Access Compliance Report

Public Rights-of-Way

(Curb Ramps)

Intersection ID: 12089	Main Street: E_12TH_ST	Cross Street: N_DAVIDSON_ST	Location: E
ADA ID: 280F289AC209	Ramp Type: PerpDiag	Initial Pass/Fail: Fail	Overall Compliance: No
		Severity Score: 37.5

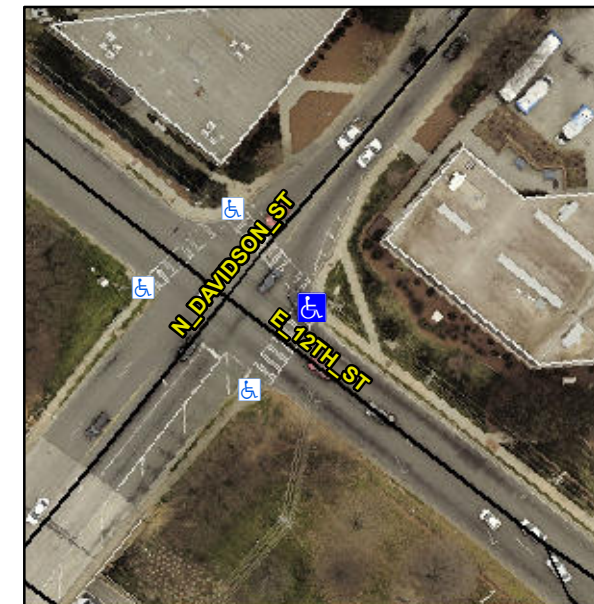
Not Found, R304.2.2, R304.5.3

Compliance	Description	Data	Compliance	Description	Data
N/A	Ramp Length (in)	59.0	No	Ramp Slope (%)	11.5
Yes	Ramp Width (in)	60.0	No	Ramp XSlope (%)	9.4
N/A	Flare Type LT	N/A	N/A	Flare Type RT	N/A
N/A	Flare Slope LT (%)	N/A	N/A	Flare Slope RT (%)	N/A
N/A	Flare Traversable LT?	N/A	N/A	Flare Traversable RT?	N/A
N/A	Landing Length (in)	N/A	N/A	DWS Provided?	N/A
N/A	Landing Width (in)	N/A	N/A	DWS Contrast?	N/A
N/A	Landing Slope (%)	N/A	N/A	DWS Length (in)	N/A
N/A	Landing X Slope (%)	N/A	N/A	DWS Full Width?	N/A
N/A	Landing Curb? (Y/N)	N/A	N/A	DWS Offset (in)	N/A
N/A	Shared Landing?	N/A			
N/A	Gutter Ponding?	N/A	N/A	Gutter Slope (%)	N/A
N/A	Gutter Lip Ht (in)	2.0	N/A	Gutter X Slope (%)	N/A
N/A	Painted X Walk1?	Yes	N/A	Painted X Walk2?	Yes
	X Walk 1 Direction	To NW		X Walk 2 Direction	To SW
N/A	X Walk 1 Width (in)	148.0	N/A	X Walk 2 Width (in)	148.0
	X Walk 1 Slope (%)	9.5		X Walk 2 Slope (%)	0.8
	X Walk 1 X Slope (%)	2.8		X Walk 2 X Slope (%)	10.6

Remove & Replace Curb Ramp With Two New Directional Ramps or Equivalent.
